Subject: NBC Standard Message 20220831_4

DA APPLICATION NUMBER: DA 2022/1252 20 The Esplanade, Narrabeen, 2101 Part Lot 32 Sec D DP7090

The proposed development submitted for approval at 20 The Esplanade Narrabeen, designed by Shobha Design for Jason and Emily Smith, is a poor example of modern architecture and impedes the amenity of its direct neighbours. This letter assesses the proposed design using the guidelines and controls found in the following documents:

Figure 1. Front Elevation shows the clear breach of B3 control. Further, the architect has not drawn the windows W-31 or W-19 that further obstruct the 'Side Boundary Envelope'.

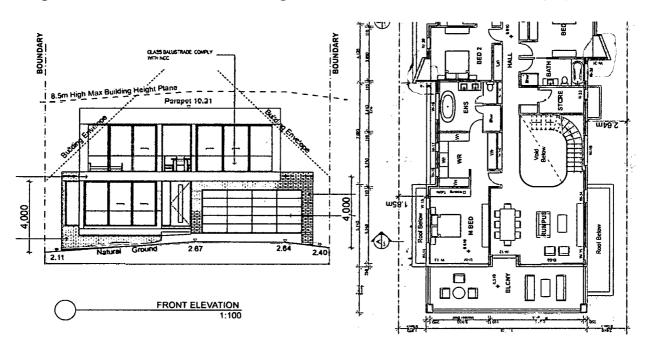
It should also be noted that the Front Elevation does not show the windows W19 or W31, which further encroach on the 'building envelope' control. It is the Architect's responsibility to ensure all design features are included in the drawings to make an accurate assessment of the proposal.

Figure 3. 9AM Winter Shadow Diagram - excessive overshadowing and incorrect labelling of neighbouring dwellings.

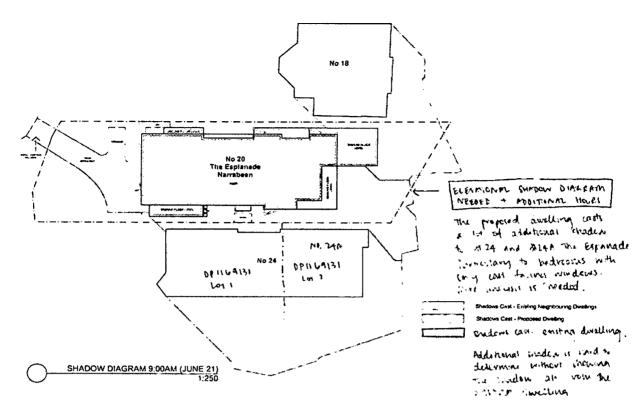
- DA-14 Shadow Diagram at 9AM June 21 shows that the proposal overshadows the entire
 eastern facade of both 24 and 24A The Esplanade. Additional shadow diagrams at 8, 10 & 11
 am need to be provided to further assess the overshadowing. Additionally, elevational
 shadow diagrams to the facades of both 24 & 24A need to be provided to determine the
 impact on their openings at these hours.

The shadow diagrams submitted (DA-14, 15, 16) are insufficient as they do not show neighbouring window locations, nor do they label the addresses correctly as 24A is missing on the diagram. It is clear from the 9AM Winter diagram, and the 3pm Winter diagram that the proposed development significantly overshadows its direct neighbours. Further hourly diagrams need to be submitted in addition to elevational shadow diagrams showing the extent of the overshadowing to neighbouring openings throughout the day. It should be noted that the rear wing of bedrooms to 24 The Esplanade only have windows facing east, which is the facade directly impacted by the overshadowing of the proposed design.

Figure 5. Proposed Front Elevation clearly portrays how the flat roof form breaks Council controls and an inappropriate choice.

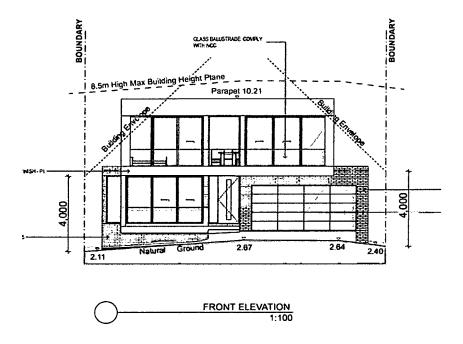
The proposed flat roof does not complement the roof pitch and forms of the existing buildings in the streetscape which are predominantly gable or hipped forms. In the immediate vicinity, there are no other flat roofs with parapets as per the proposed. The siting, reduced front setback and the introduction of a second storey would more appropriately suit a more considerate roof form such as a gable roof to reduce the bulk and height of the proposed dwelling at the boundaries. This would in turn reduce the numerous negative impacts on neighbouring homes including excessive overshadowing, view loss and bulkiness.

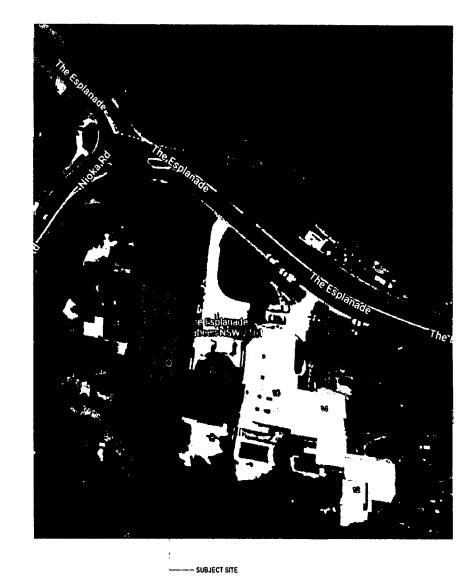
- No outline of the existing dwelling to be demolished is shown.
- The sun position shown is wrong at 9am and 3pm.
- Views and solar access enjoyed by adjacent properties is not shown. Views have been heavily impacted by the proposed development. It is imperative that an in-depth view loss analysis is submitted by the applicant.

- landers bee not shown with street/ iverangour's DWELLING CONTEXT.

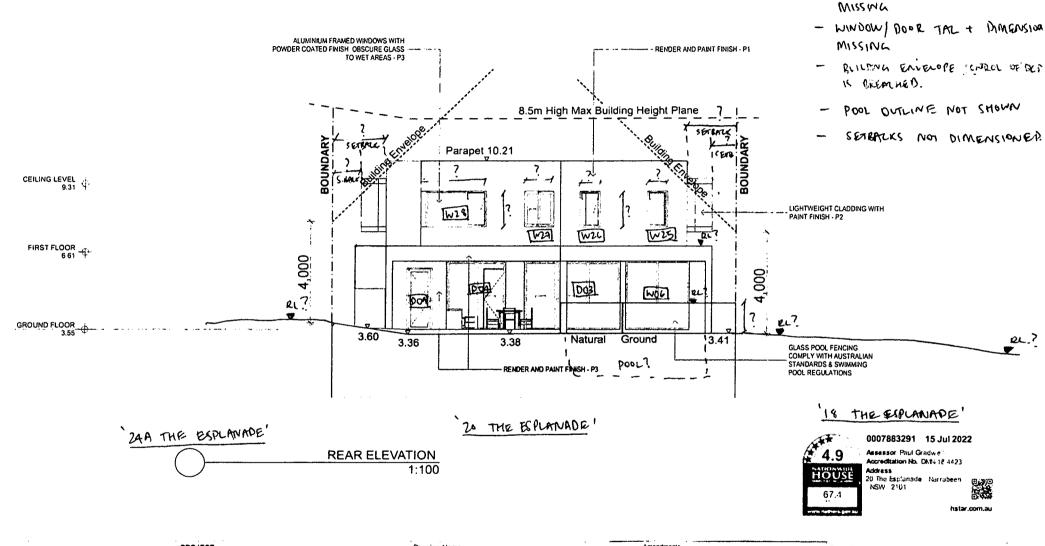
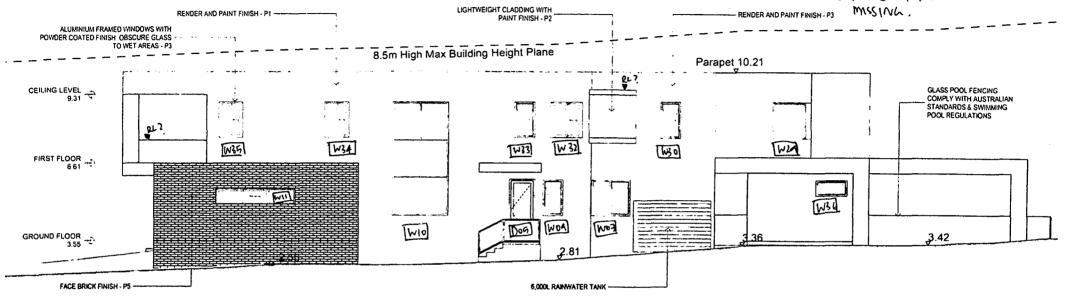
DWELLINGS MISSING.

- ELEVATIONS + PLLS OF NEACHBOURIN

OUTLINE OF EXISTING DWELLIN

- SIDE ELEVATIONS OF NEIGHBOURAVL DINEWING (+ MLS) BEYOND, MISSING.
- WINDOW/DOOK TARKS + DIMENCIONS Missur

SECTION C 1:100

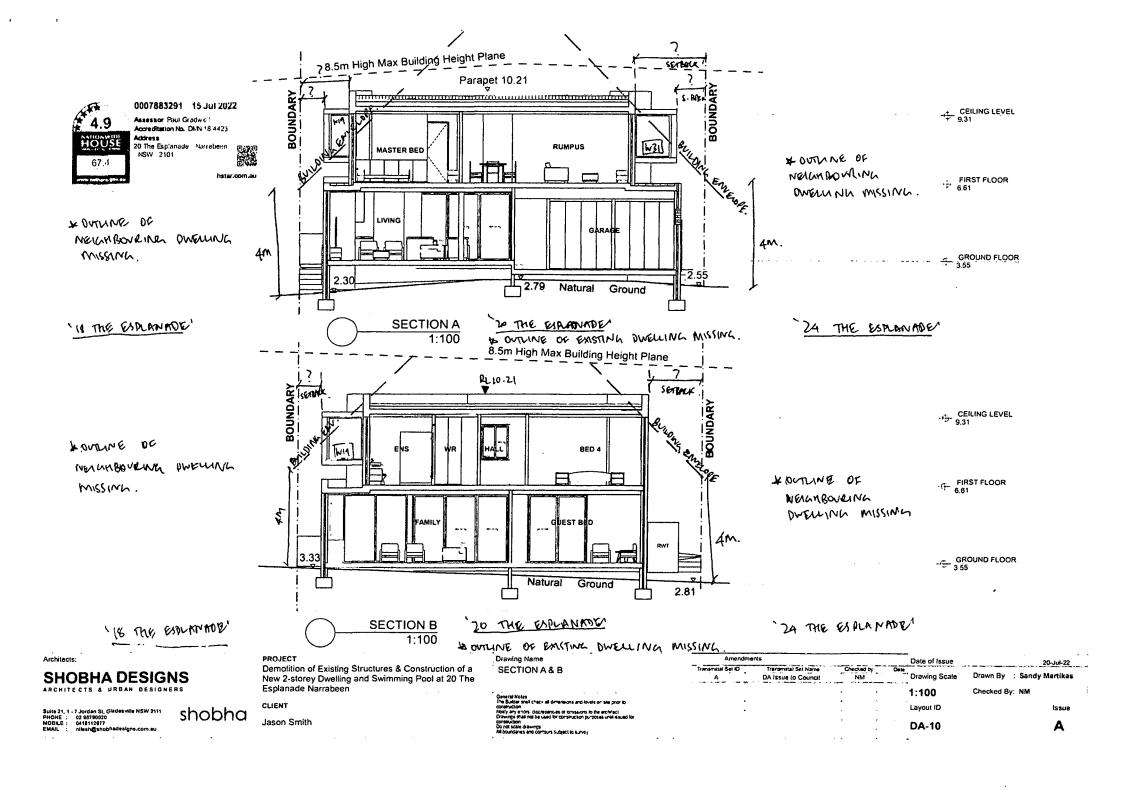
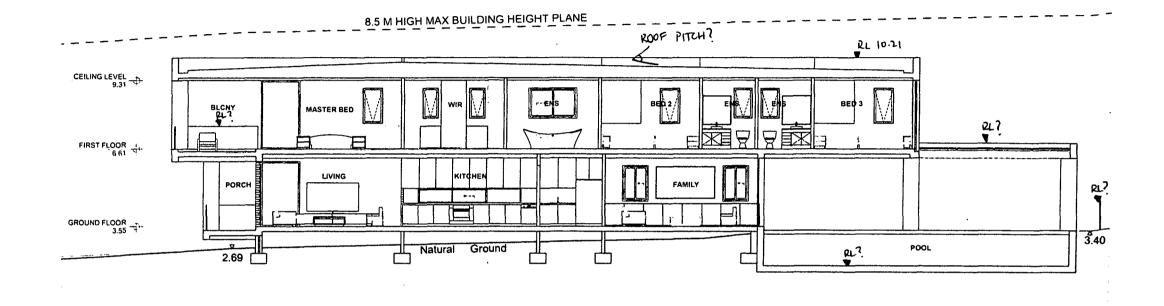
- Outline of existing building to be demolished is missing.
- No roof pitch is indicated.
- Important RLs are missing to roof, pool, fences etc.
- No outline or mention of any adjoining buildings/fences is shown. Therefore, RLs of neighbouring buildings is also missing.
- Doors and windows have not been identified or dimensioned.
- Side boundary setbacks have not been dimensioned.
- The 'side boundary envelope/building envelope' has not been shown on the cross sections on DA-10. When drawn, it is clear to see that the proposed design breaches this DCP control.

* OUTLINE OF EXISTING DWELLING MISSING.

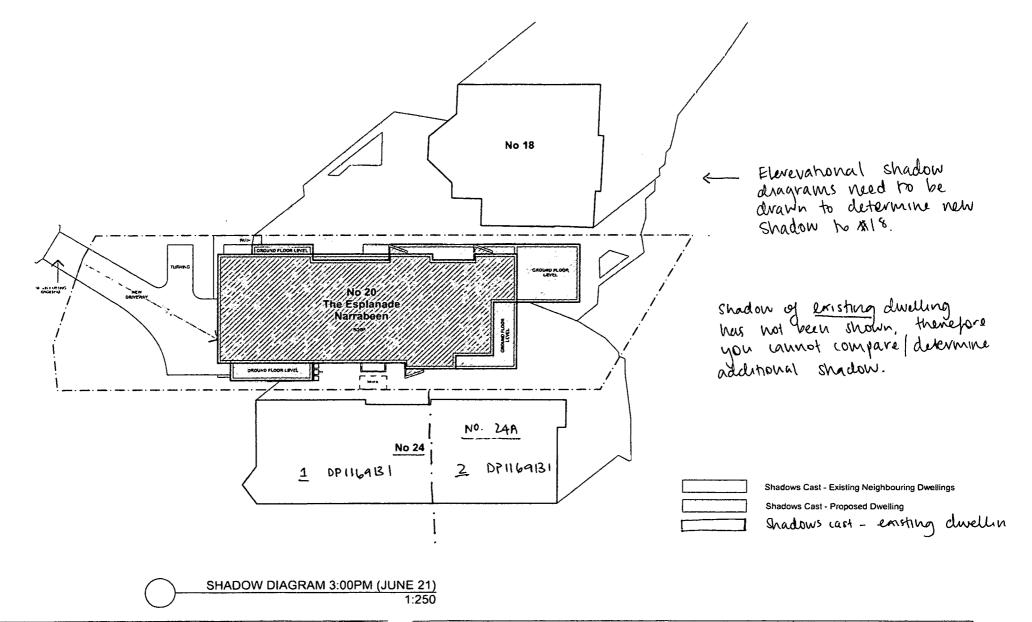
- DA-16 Shadow Diagram at 3pm June 21 shows that the proposed development severely overshadows the dwelling at 18 The Esplanade. Additional shadow diagrams at 1, 2 & 4pm need to be provided to further assess the overshadowing. Additionally, elevational shadow diagrams to the impacted facades of 18 The Esplanade need to be provided to determine the impact on its openings at these hours.
